**PUBLIC HEARING DRAFT OF THE SANDY SPRING RURAL VILLAGE PLAN  
AN AMENDMENT TO THE APPROVED AND ADOPTED 1998 SANDY SPRING/ASHTON MASTER  
PLAN**

RE: Sandy Spring Rural Village Plan Planning Board Public Hearing Draft

**Executive Branch Comments  
August 29, 2014**

**HOC's Requested Changes to the Public Hearing Draft**  
**of the Sandy Spring Rural Village Plan**

Sandy Spring Meadow and Parcel 338

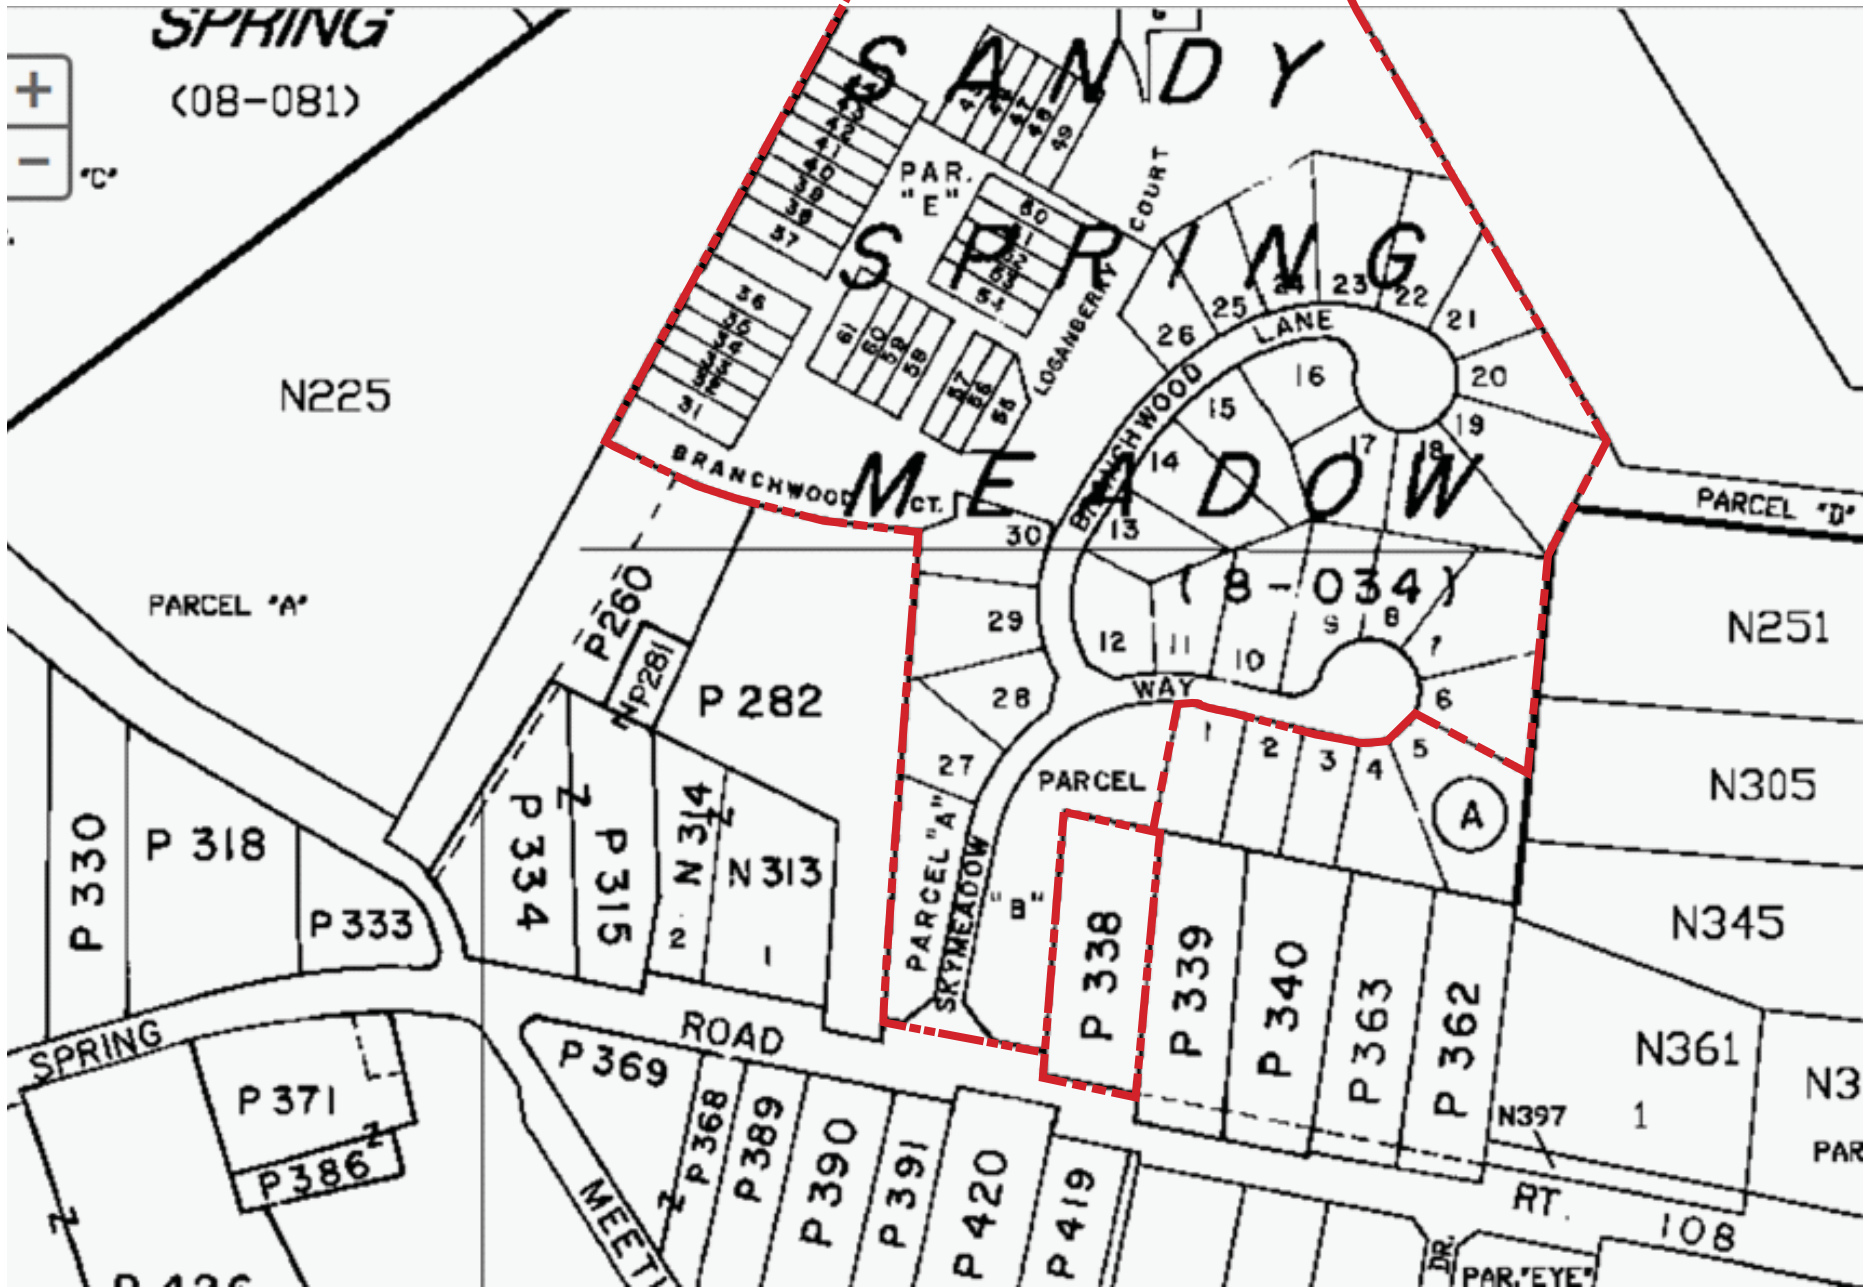
- HOC is in the process of purchasing the property located adjacent to its property (identified as Parcel 338 located at 617 Olney-Sandy Spring Road) to implement several of the master plan objectives and to better link our community to the Village Center. HOC wishes to resubdivide the HOC-owned land in the Sandy Spring Meadow subdivision and Parcel 338 to allow for the construction of additional housing units (*see concept plan*).

- **In order to achieve the additional units on Parcel 338 in the most flexible, appropriate and compatible manner, we request that the zoning for Parcel 338 be changed from R-200 to R-60 so that it will be in the same zoning category as the adjacent HOC-owned land.**

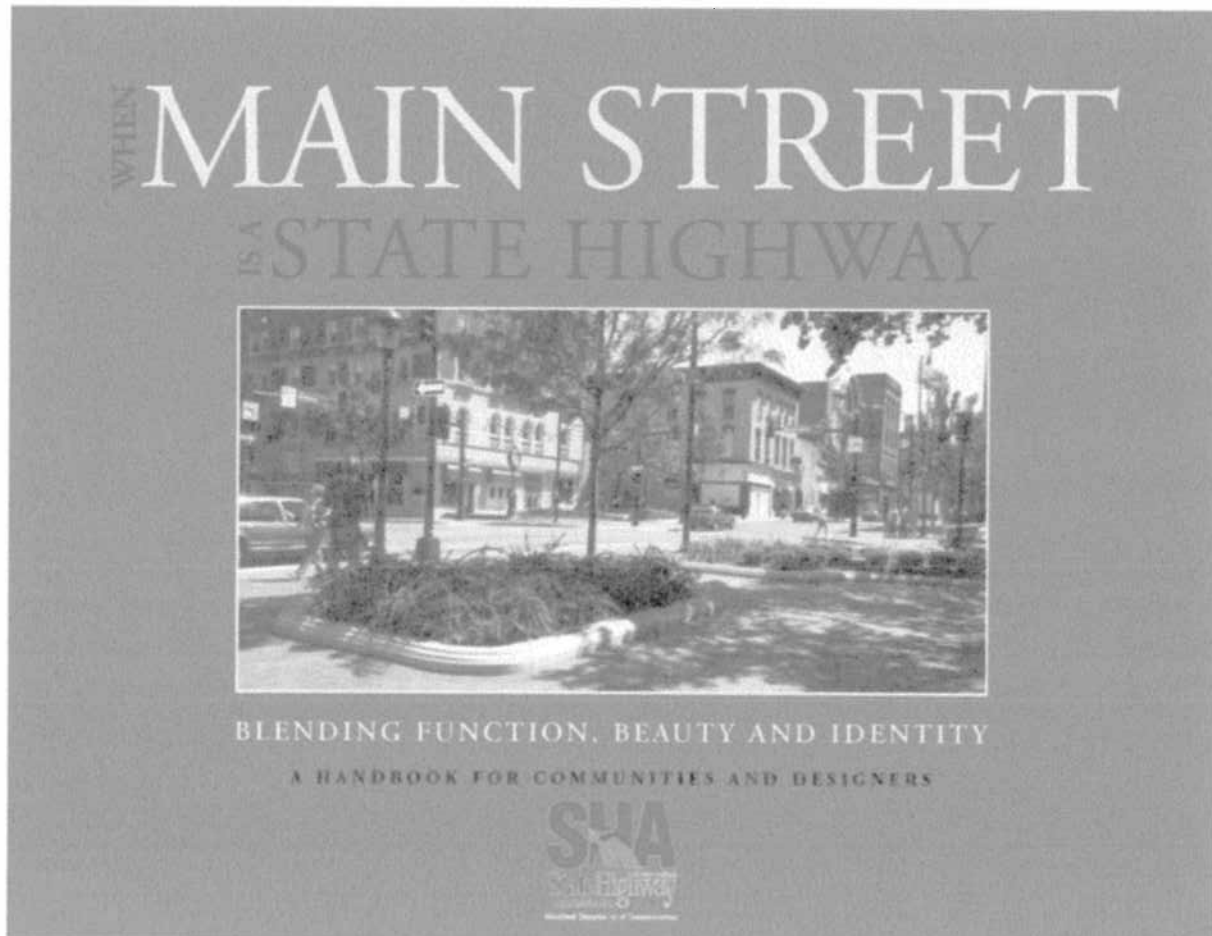
A few photos of other village center sidewalks, all of which have higher densities and greater pedestrian traffic; none of which have a sidewalk section as large as proposed in the draft Plan.

## Sidewalk Section - Village Core

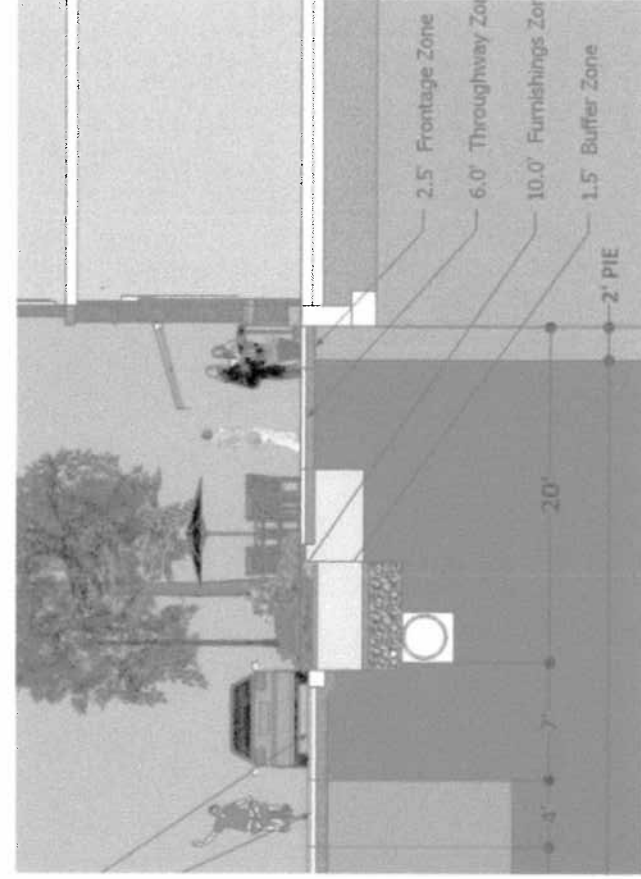
I respectfully suggest that, since a bicycle lane is required on MD 108 (footnote 3), a 10-foot shared use path at the Village Core would be redundant, and inconsistent with this Village Core context. The bike lane, in combination with a properly scaled sidewalk will provide the needed movements, and in a manner that is contextual with the character of the Village Core.

I have attached two sections. The first section, interprets the narrative on pages 35-36. The second section is a suggested alternative that achieves the goals of the draft Plan, but in a way that is in scale with the Village Core.

**Provide a context-sensitive solution for the Village Core (from Brooke Road to Skymeadow ) that separates the bike and pedestrian traffic in this short area, utilizing the required bike lane and new sidewalk.**

- Page 35, last paragraph: "From the new buildings on the north, the right-of-way will contain a sidewalk, a 5-foot bike lane with a buffer between the sidewalk, and on-street parking."
- Page 39, second bullet: "Accommodate bicycle and pedestrian movement on north side MD 108"
- Page 44, second paragraph: "The Plan supports the recommendation for a 10-foot wide share use path, with modifications allowed at the Village Core, on the north side of MD 108 connecting the elementary school to the high school."
